**From:** amanda@adt.com.tw [mailto:amanda@adt.com.tw]  
**Sent:** Thursday, April 27, 2006 3:07 AM  
**To:** steve.cheng  
**Cc:** eric@adt.com.tw; may@adt.com.tw; Ken\_Lu@adt.com.tw  
**Subject:** Done! : TCB Review Comments for (B06-0426c- Q87-WRT300NV1,950420H02- Cisco 11n Router)

**TCB Review Comments for (B06-0426c- Q87-WRT300NV1, 950420H02- Cisco 11n Router)**

CH7

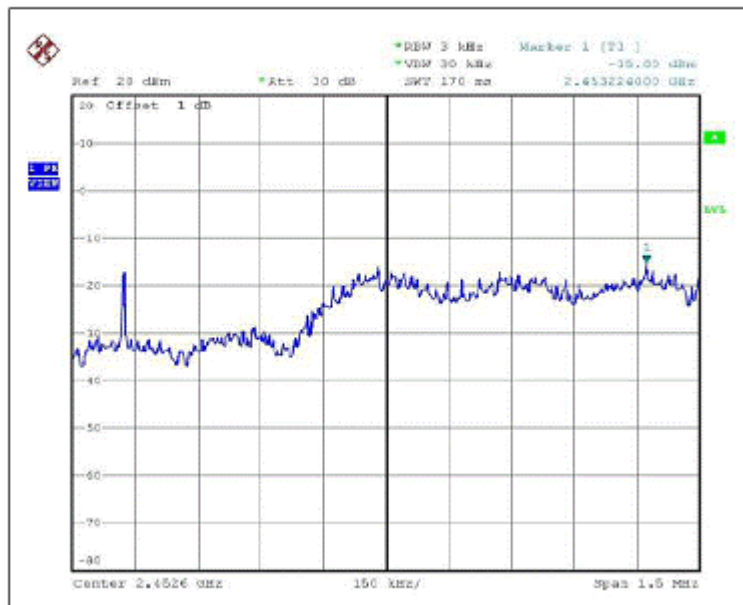
Question #1: P 136 or test report Sweep Time setting is wrong please re-take data.

=> Plot has been re-measured with correct setting and test report updated.
